**Rehabilitation of former industrial land, McCabe
Street, Mosman Park — proposal for management
of additional waste volumes — proposed change to
environmental conditions**

LandCorp and Octennial Holdings Pty Ltd

**Report and recommendations
of the Environmental Protection Authority**

**Environmental Protection Authority
Perth, Western Australia
Bulletin 863
July 1997**

Figure 2. Location of additional contaminated materials, McCabe St, Mosman Park. (Modified from Halpern Glick Mamsell 1997a).

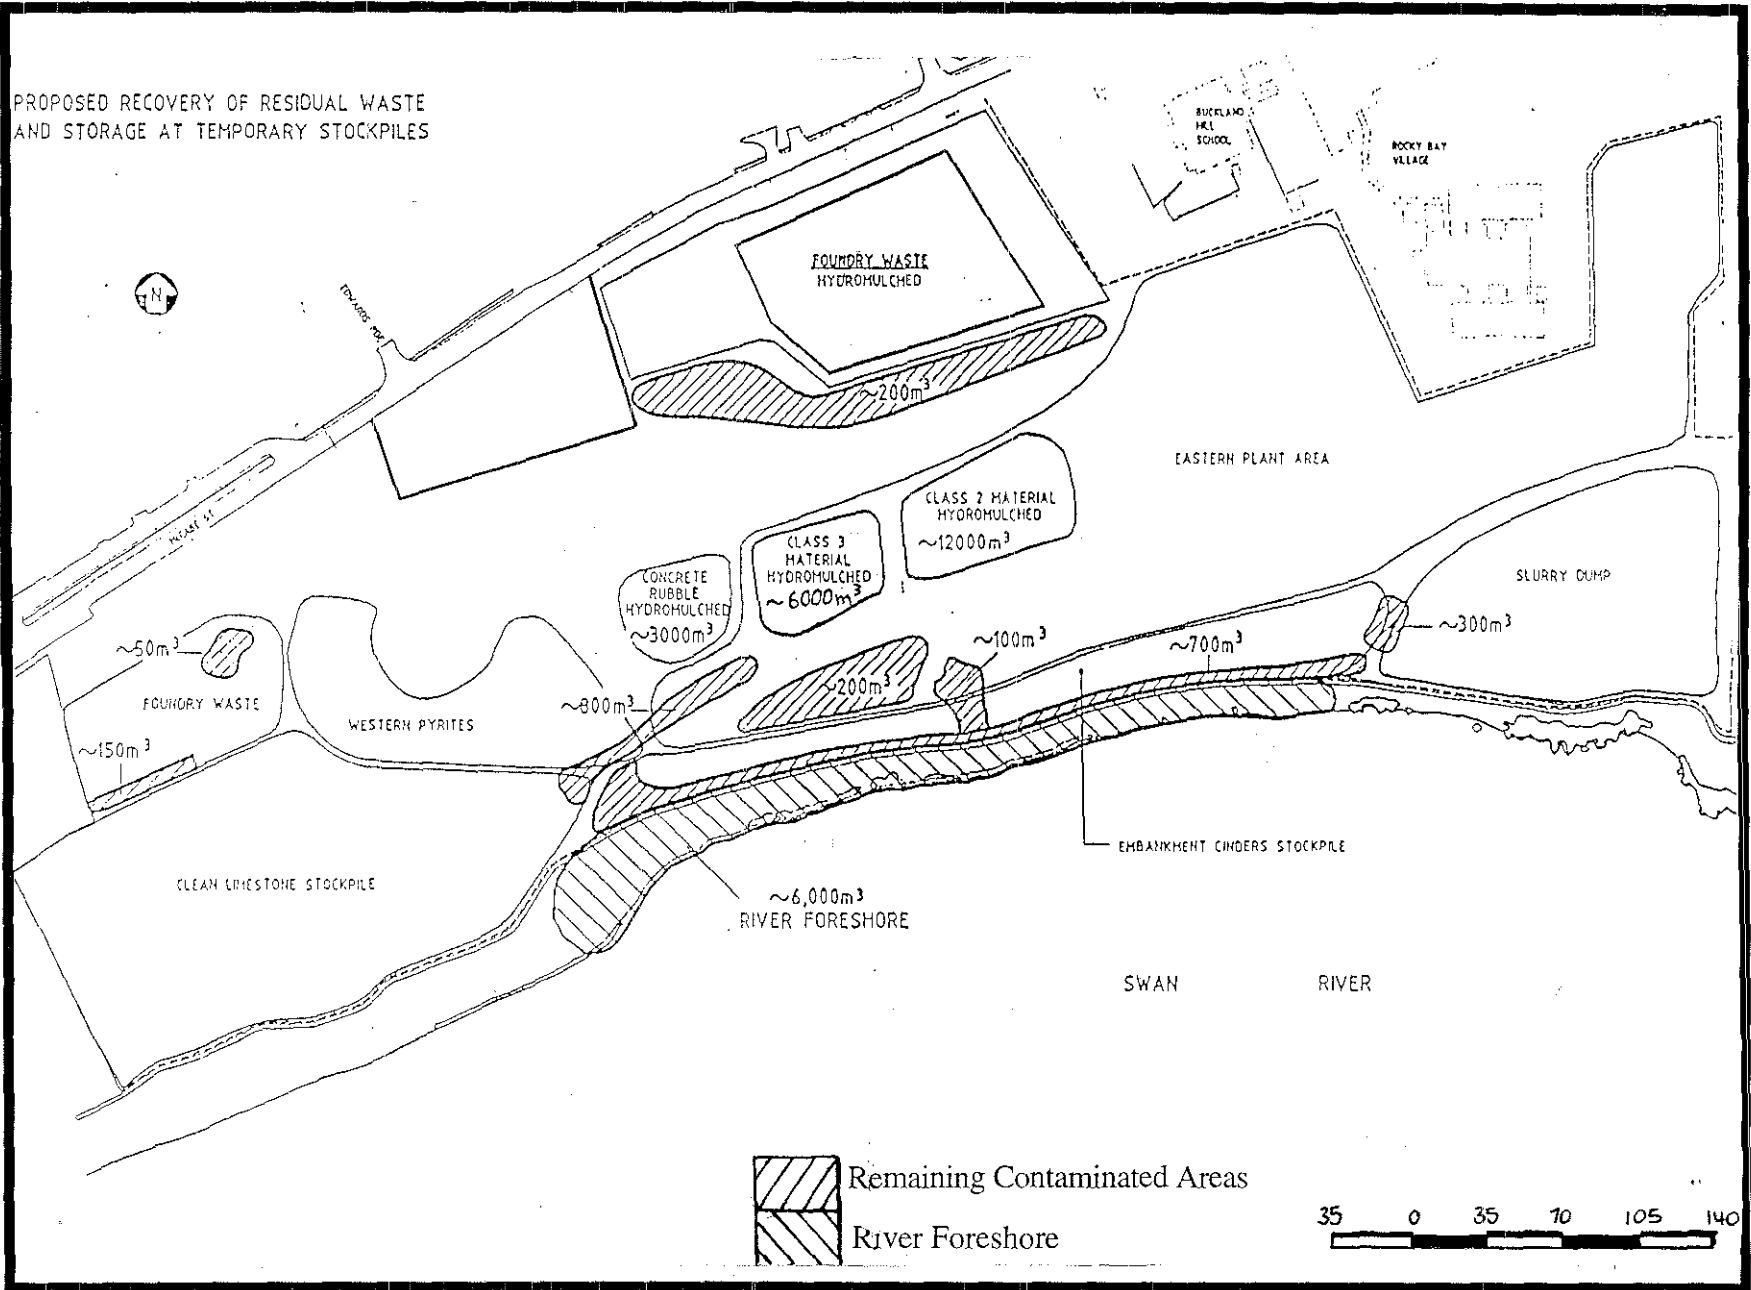
Approximately 8,000 m³ of the additional 67,500 m³ contaminated materials comprise contaminated materials from the areas remaining from the previous cleanup operations (Appendix 1:Figure 2) and allowances for potentially contaminated soils below stockpiles. It is proposed that the cleanup of these areas should be undertaken to the requirements of existing Environmental Conditions 4-1 and 4-2 (Appendix 3) such that the site would be suitable for residential use. This would be achieved by reducing concentrations of heavy metals to less than the soil investigation levels listed in the Environmental Soil Quality Guidelines presented in the Australian and New Zealand Guidelines for the Assessment and Management of Contaminated Sites (ANZECC/NHMRC 1992). Heavy metals contaminants of concern and their corresponding cleanup levels in mg/kg are:

Figure 3. Typical cross section through containment cell, McCabe St, Mosman Park. (Modified from Halpern Glick Maunsell 1997a).

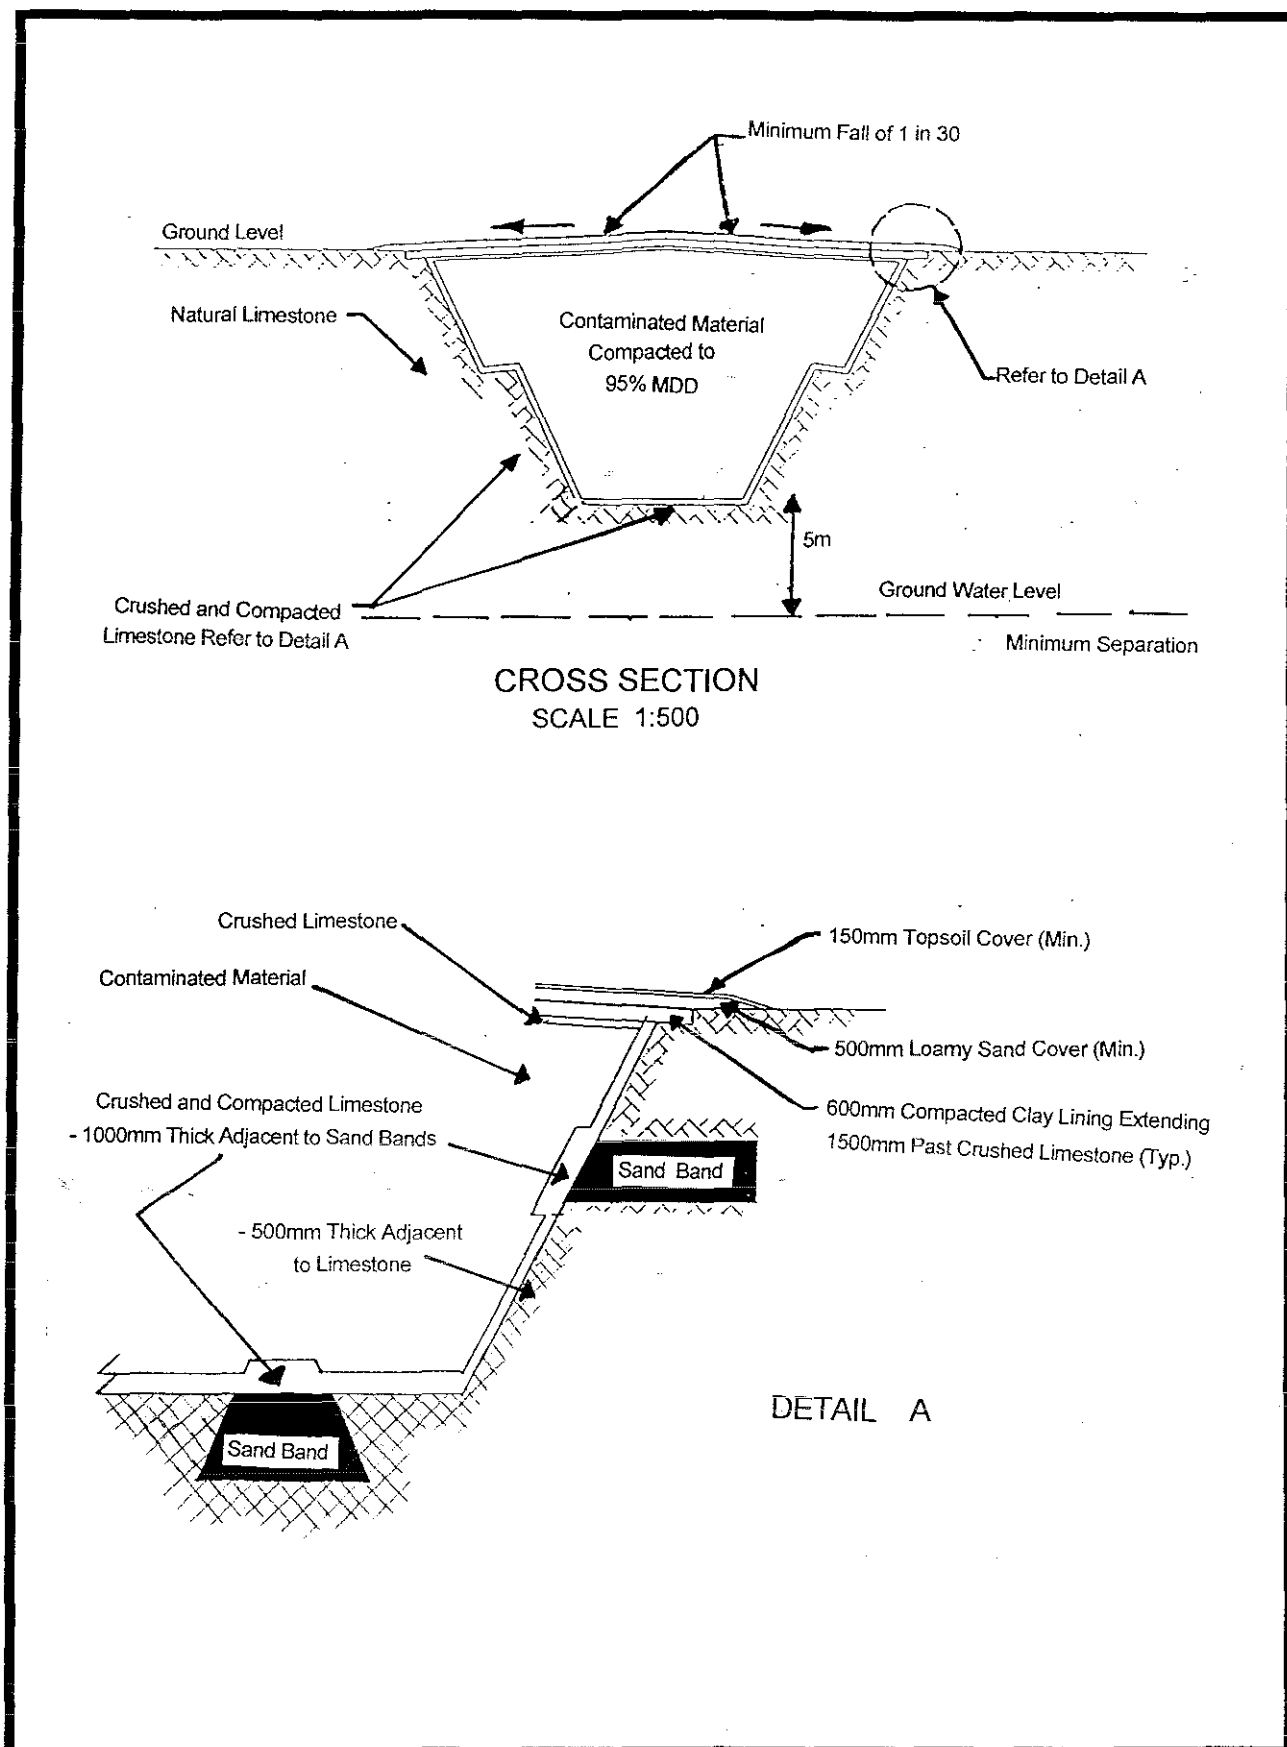
- placement of a capping system, containing a low permeability clay layer with a minimum thickness of 600mm (Appendix 1:Figure 3);
- use of clean materials excavated from the cells as fill on the site to meet subdivision requirements;
- a waste volume contingency strategy comprising:
 - provision of additional storage capacity in the cell of about 20% (approximately 13,000m³) on the expected volume of wastes (approximately 67,500m³); and
 - off-site disposal in appropriately licensed landfills of material in excess of the maximum capacity of the cell (approximately 80,000m³), with transport of any contaminated materials off-site under the control of an environmental transport management programme;
